ADDENDUM NO. 1

September 1, 2022

CROWN POINT HIGH SCHOOL ATHLETIC FIELDS AND SITE IMPROVEMENTS
Crown Point, IN 46307

SHEET
C-2.1

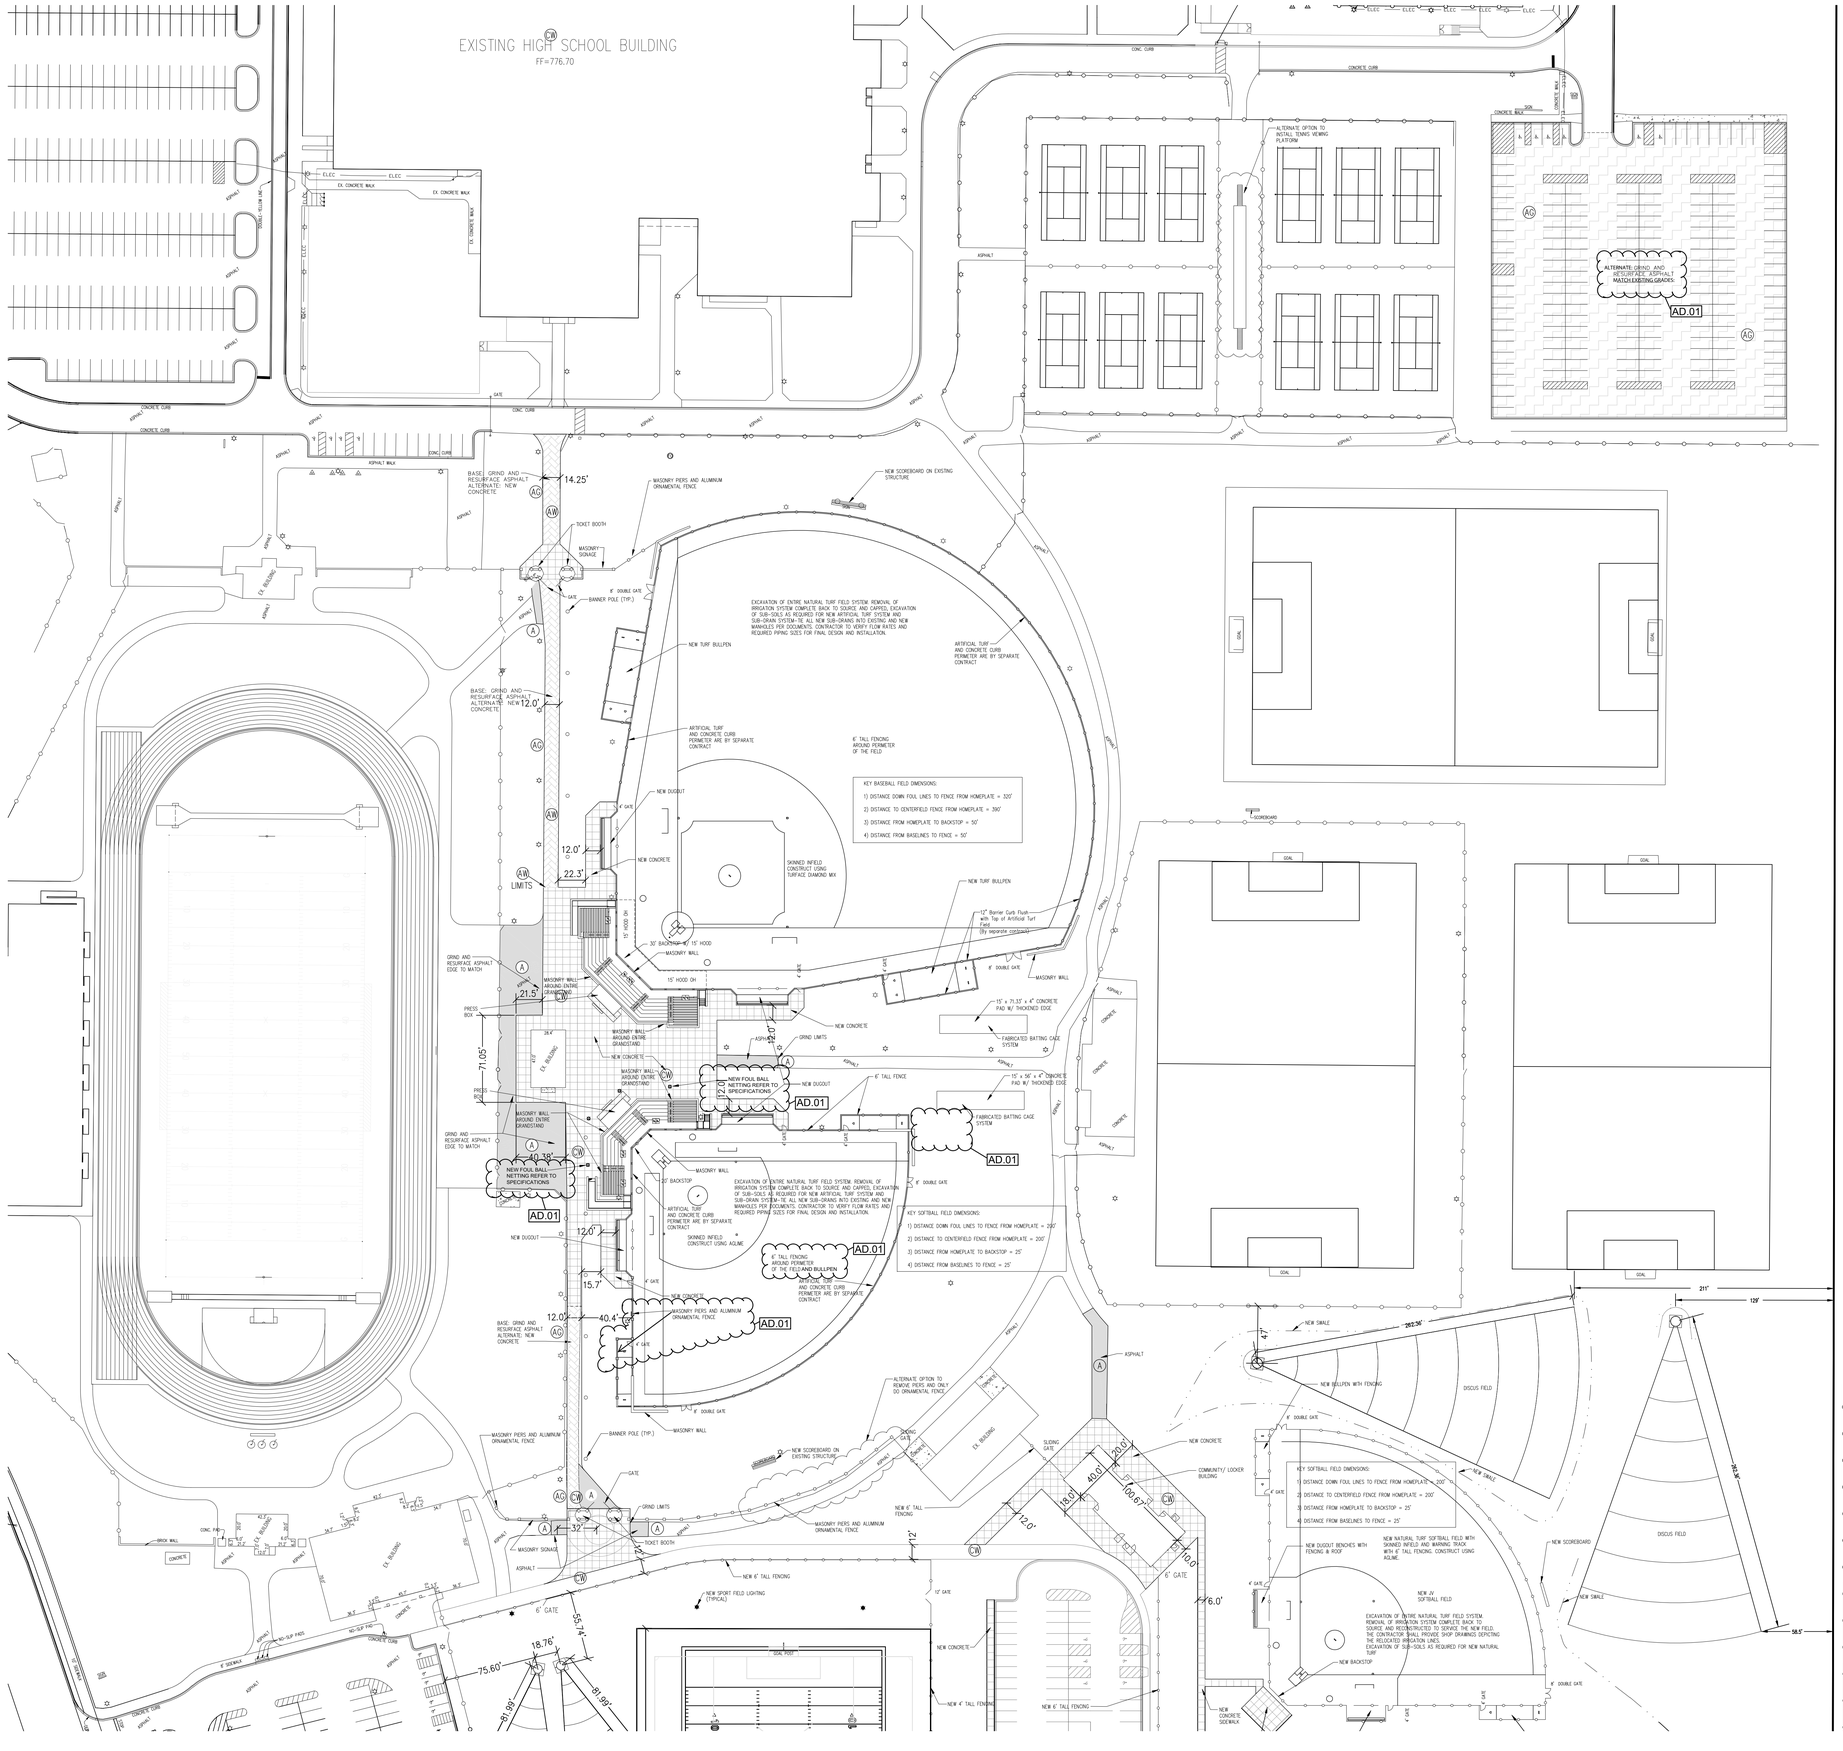
6. **Sheet C-2.0**
   A. Disregard plan notes on this sheet. Refer to enlarged site plans on sheets C-2.1 and C-2.2 for plan notes.
7. **Sheet C-2.1**
   A. Refer to revised, full-size drawing, included in this Addendum, for revised plan notes as indicated on drawing.

SHEET
C-2.1A

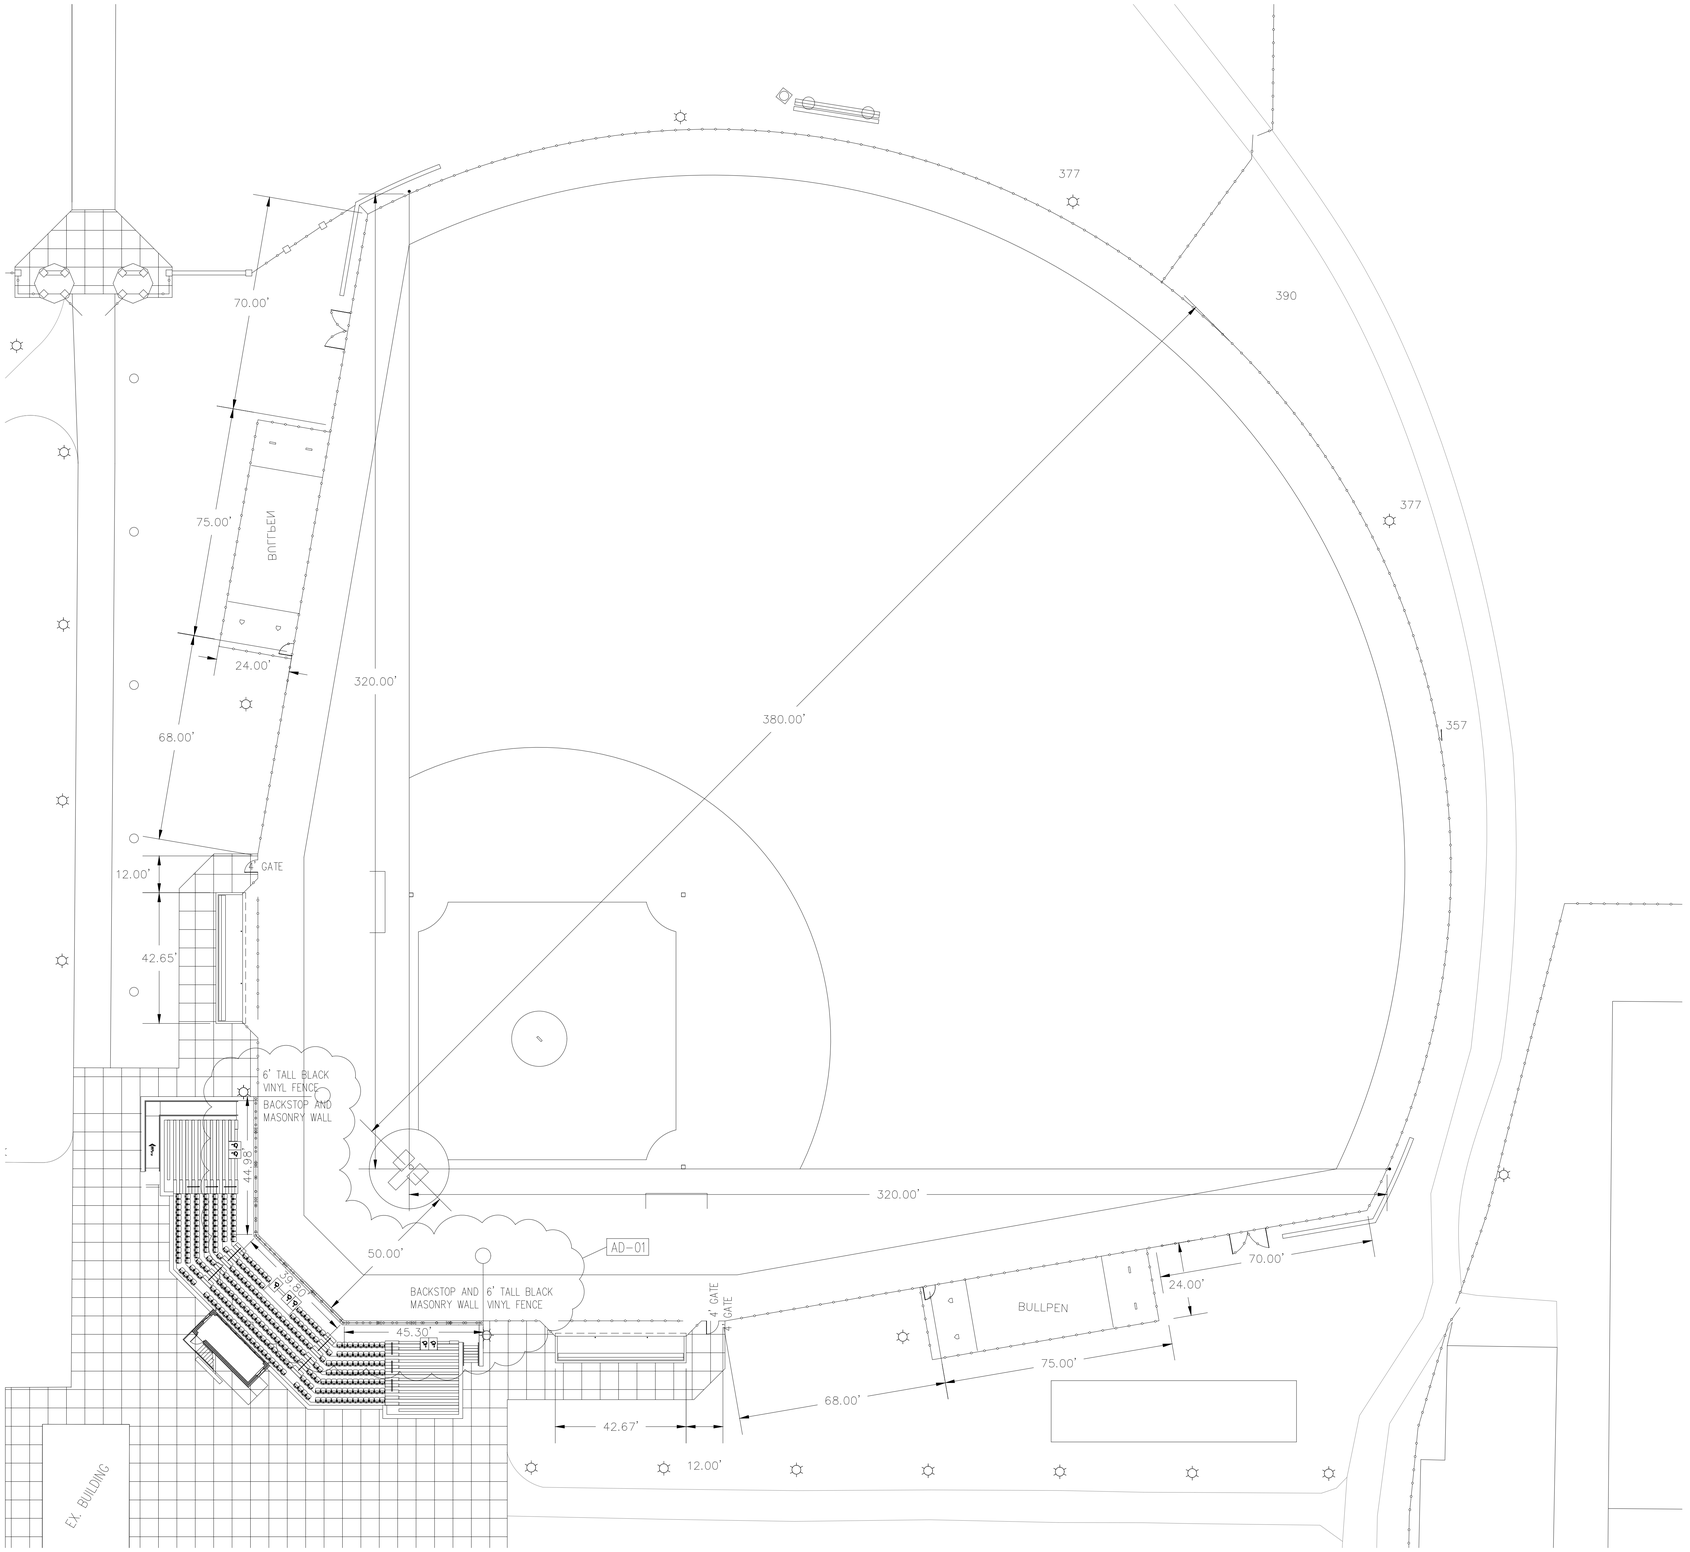
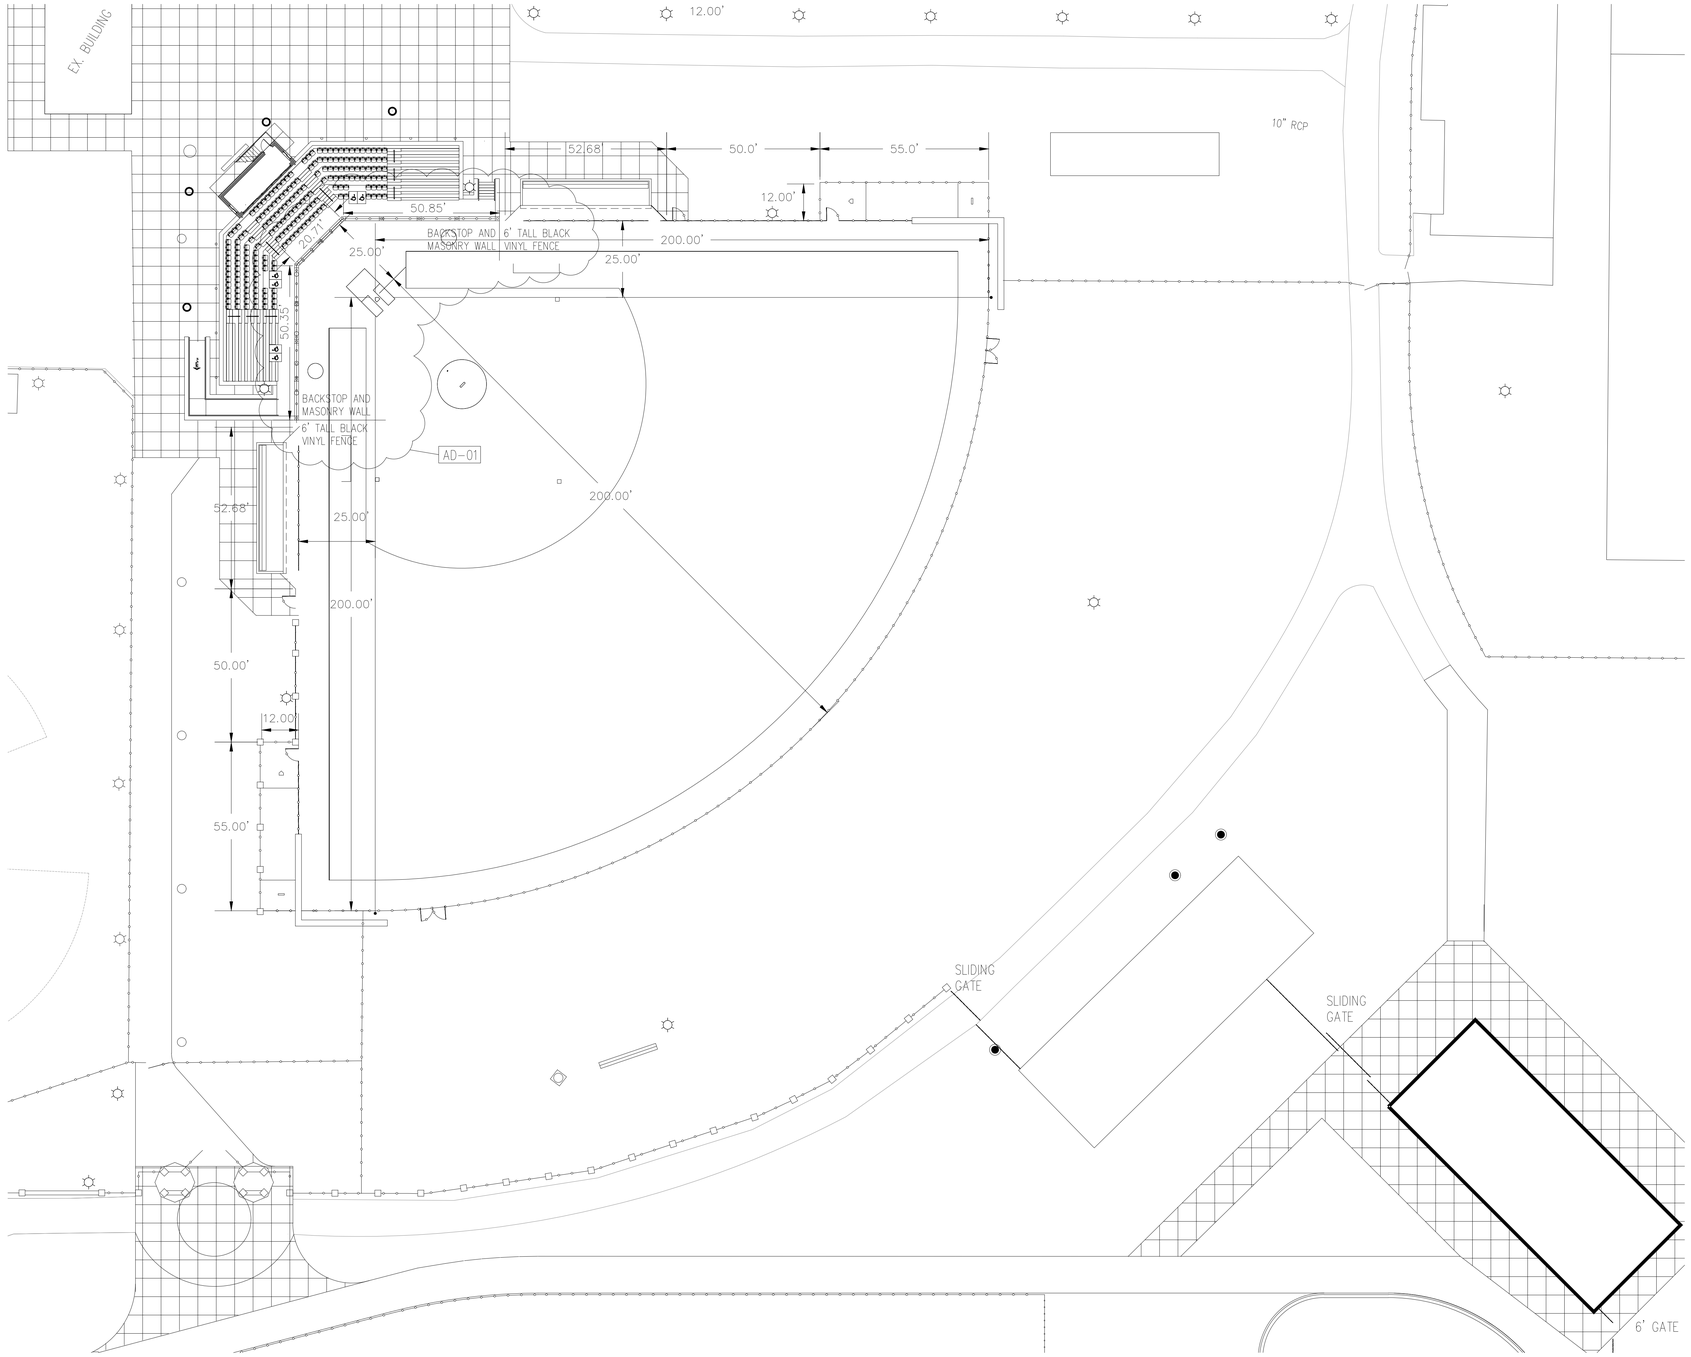
A. Refer to two (2) attached revised full-size drawings, included in this Addendum, for the following revisions:

1. Add additional dimensions for clarification.
